**Draft Port Phillip Planning Scheme Amendment C195port  
240-246 Normanby Road, South Melbourne**

**Fishermans Bend Standing Advisory Committee Report – Tranche 5 Report**

**23 June 2022**

**Figure 4 Comparison of approved and proposed building heights – Montague Street elevation**

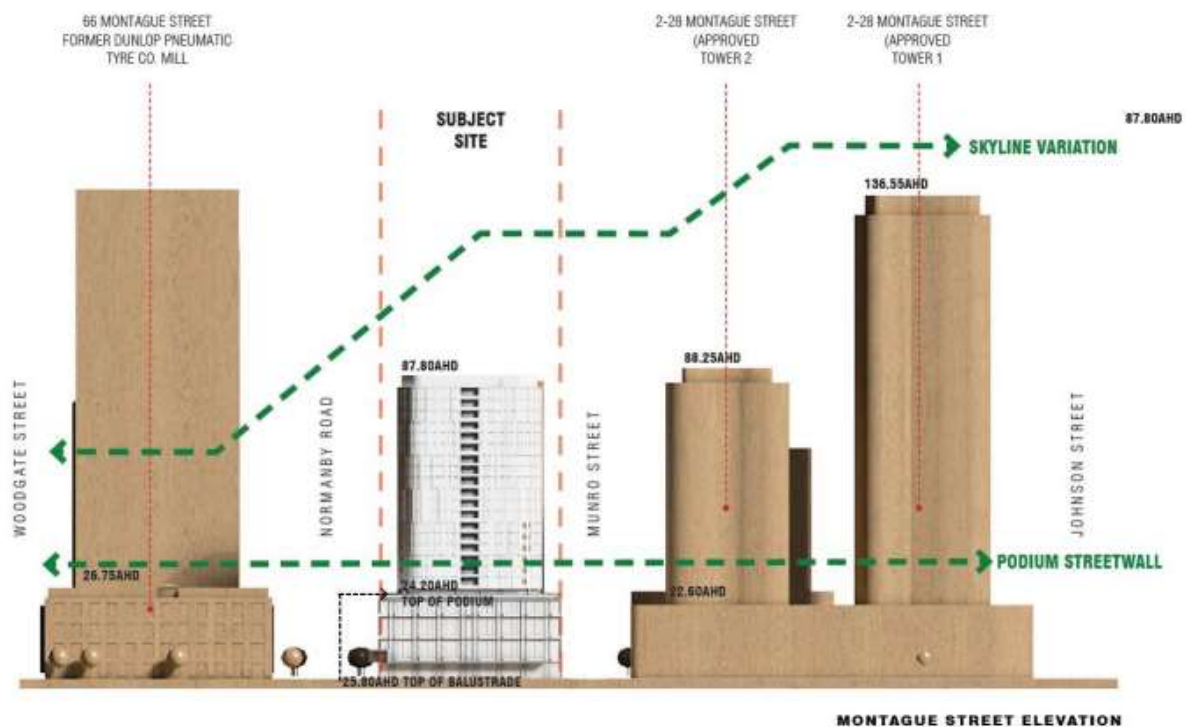
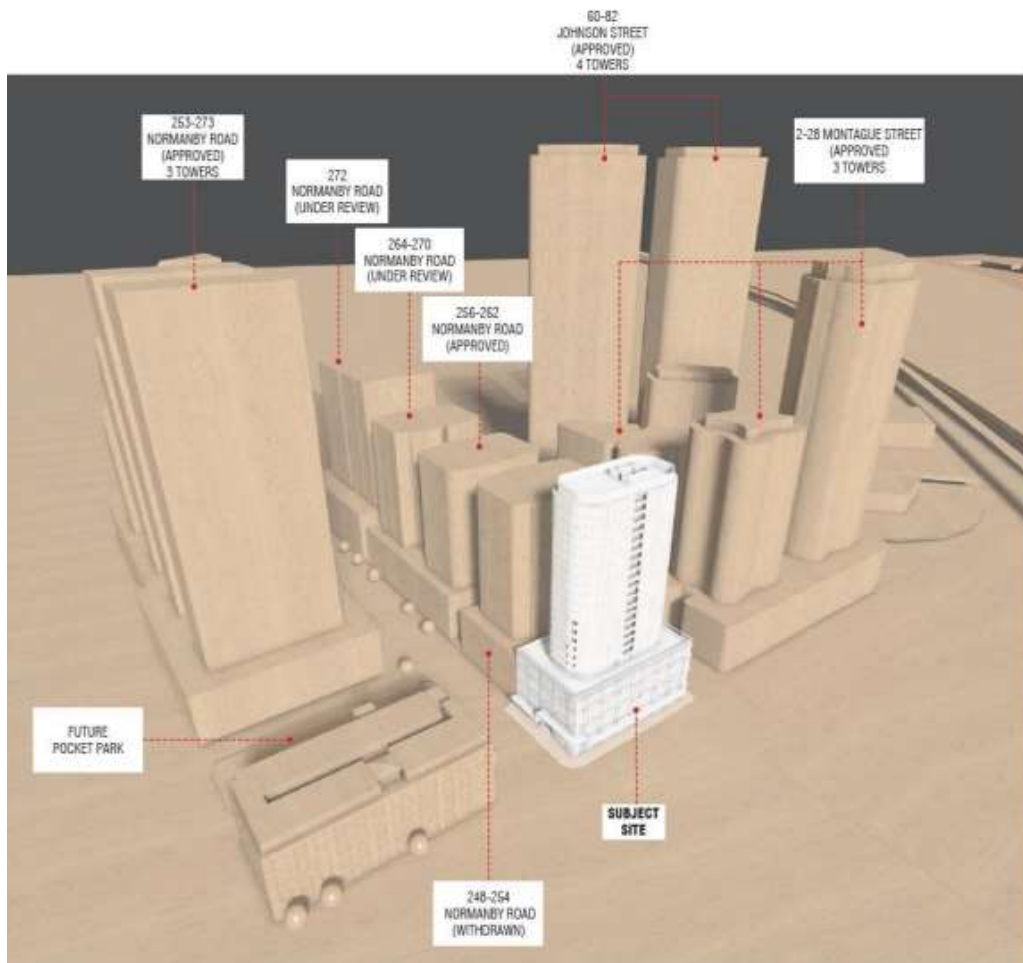
The proposal is for a 25 storey development<sup>6</sup> (83.3 metres AHD) which exceeds the preferred height by 5 storeys or 15.3 metres.

Figure 4 shows a comparison in height (Montague Street elevation) between the proposed development and nearby approved developments (which are also identified in Figure 5 in oblique view including buildings along Normanby Street). Precinct approvals are shown in Figure 6 which depicts approved heights and storeys, status of approvals and development (including those approved prior to GC81).

The Committee is of the view that the proposed height is acceptable, both within the context of approved and constructed developments, and within the planning framework for the Montague North precinct. The Committee agrees with Mr McGurn that all parts of the planning scheme must be reconciled meaning the 'building typology' in Table 1 must be read alongside the 'preferred precinct character' of the table and reference map (Map 2).

**Figure 9** Amended plans - Level 1: Pool Area, Steam and Sauna Areas

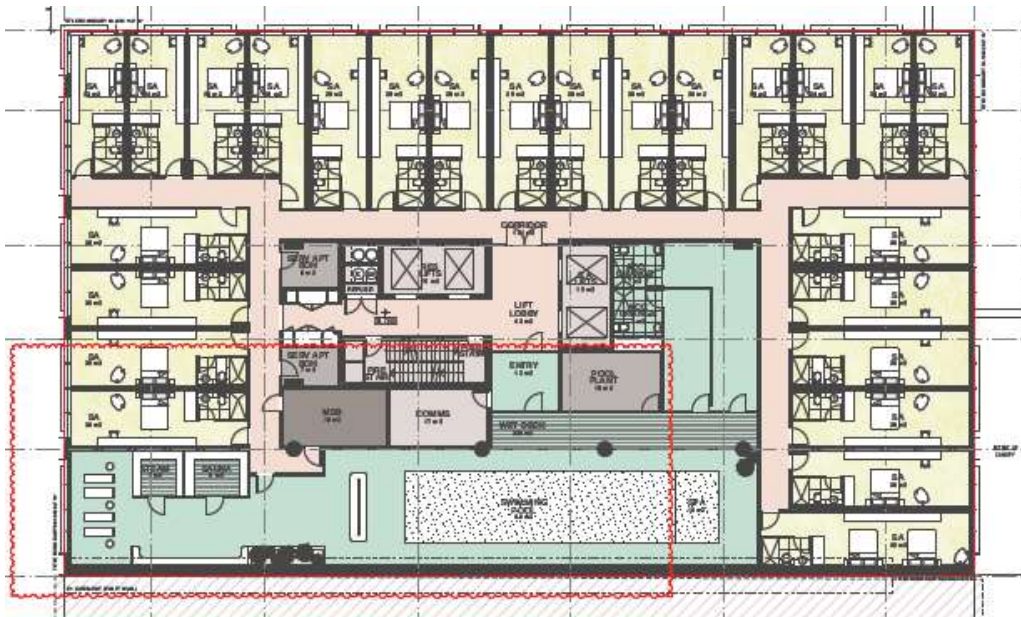
- Level 01 Floor Plan: (refer Figure 9)
  - 1. Pool environment extended to Munroe Street.
  - 2. Two (2 of) serviced apartments removed.
  - 3. Sauna, steam and relaxation spaces relocated to Munro Street.
  - 4. Pool Plant and comms room relocated.
- Level 02 Floor Plan: (refer Figure 10)
  - Gym Active spaces extended to Munroe Street. Overlooking of Pool void retained. Yoga Room located against Munroe Street façade.
  - Comms & Cleaners Room relocated.
- Level 04 Floor Plan: (refer Figure 11)
  - Void from top of podium extended to this level. Outdoor terrace and light well provided. Minor loss of area to apartment gym
- Level 05 Floor Plan: (refer Figure 12)

areas depicted in the amended without prejudice plans represented improvements, but that further consideration and refinement was required.

**Figure 10** Amended plans - Level 2: Serviced Apartment gym, Yoga Studio and void to pool below

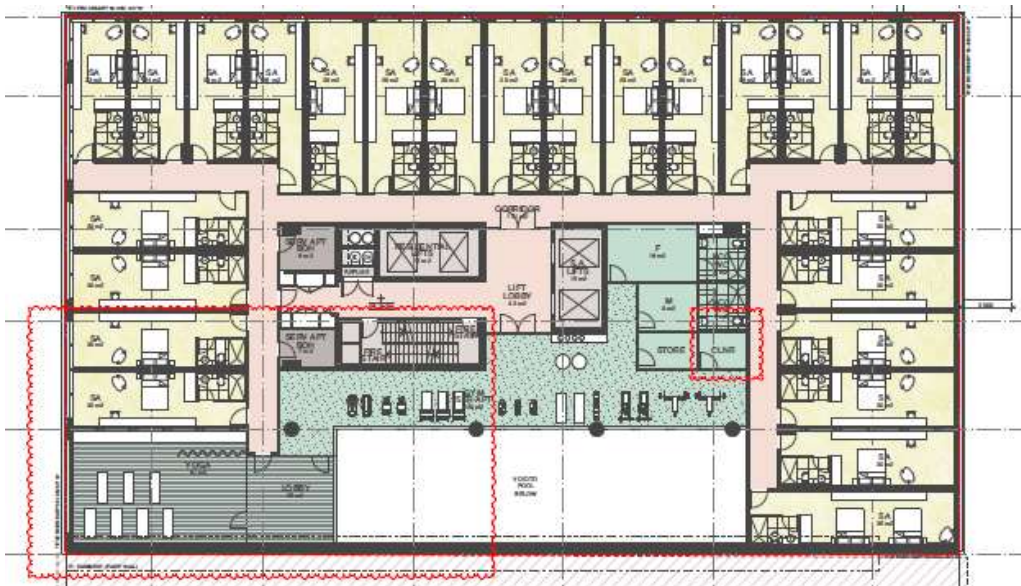
- two serviced apartments removed
- TP101 Level 2 Floor Plan - Gym and yoga spaces extended to Munro Street
- TP104 Level 4 Floor plan:
  - void from top of podium extended to this level

Figure 11 Amended plans - Level 4: Apartment gym and Terrace

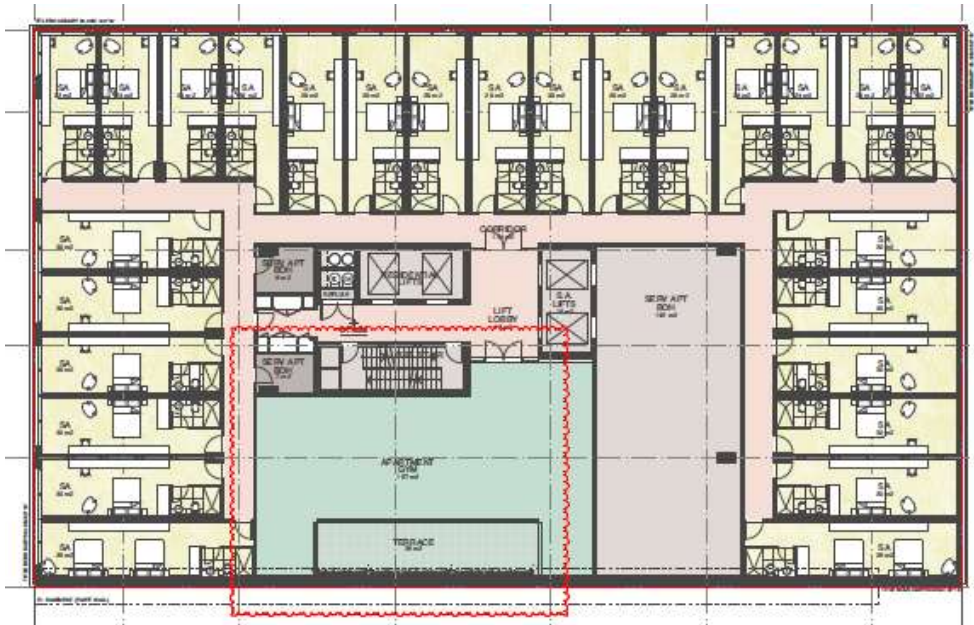
- outdoor terrace and light well provided
- TP105 Level 5 Floor plan - void from top of podium extends to this level. light well provided with vertical green element to south-western wall

Figure 12 Amended plans - Level 5: Amenities/Void and Green wall

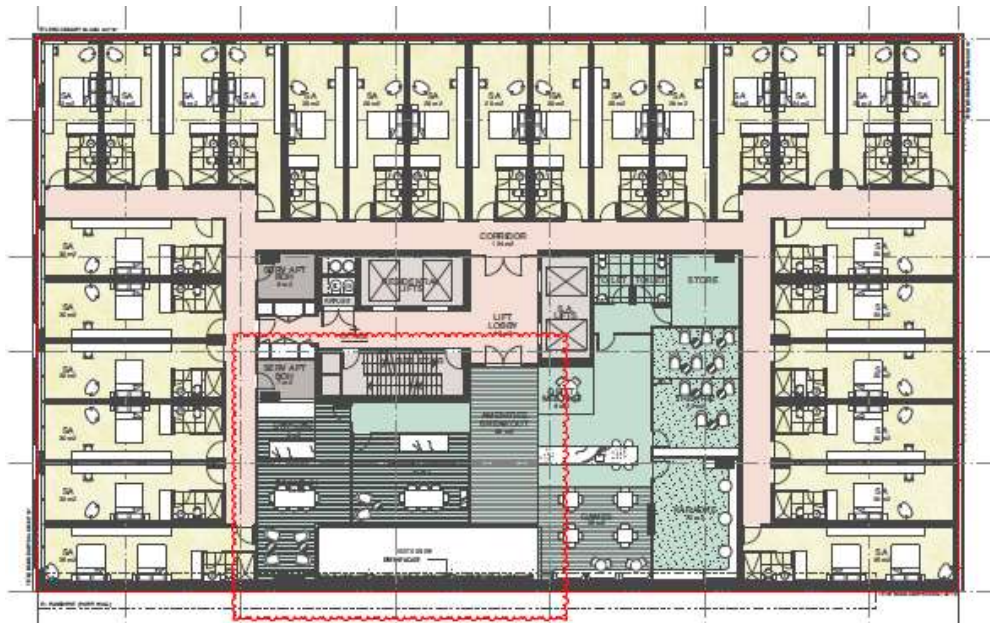
- Void from top of podium extended to this level. Light provided with vertical green element to south-western wall. Minor loss of area to amenities.
- Level 06 Floor Plan: (refer Figure 13)
  - Void to podium levels below added to improve amenity.
  - Common amenity area increased and extended to Munro & Montague Streets to take advantage of views and sunlight.
  - Landscape reconsidered as series of rooms to provide multiple options for residents.
  - Single apartment replaced with common amenity spaces.

**Figure 13 Amended plans - Level 6: Amenities (Indoor/Outdoor & Terrace)/Green wall**

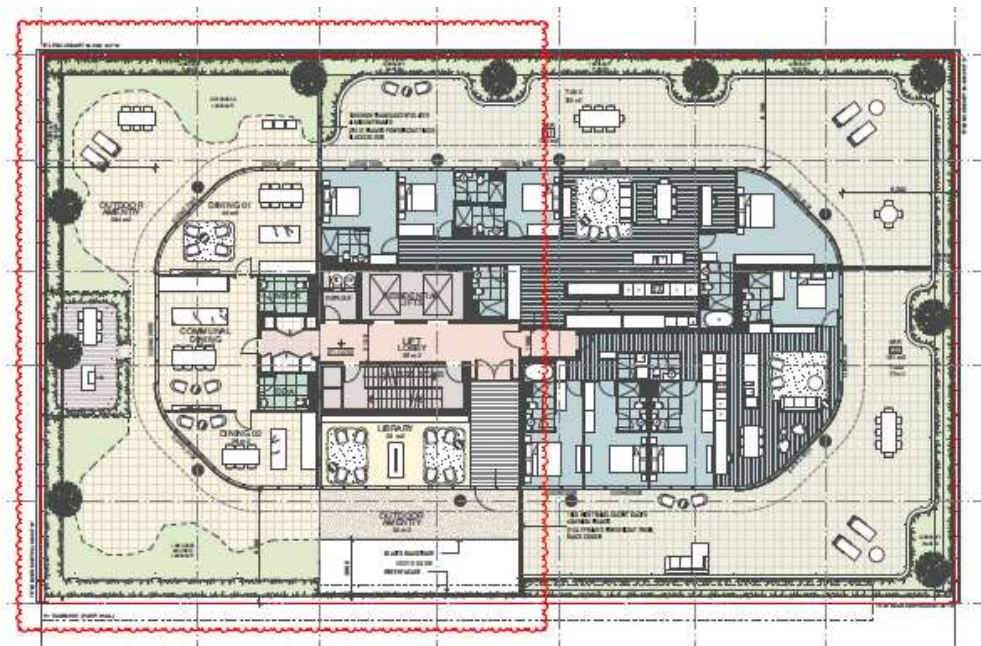
- TP106 Level 6 Floor plan:
  - void to podium levels below added to improve amenity
  - common amenity area increased and extended to Munro and Montague streets

- landscape reconsidered as series of rooms to provide multiple options for residents
  - single apartment replaced with common amenity spaces
- TP107 Levels 7-11 – apartment levels modified to address Clause 58 provisions and submission comments
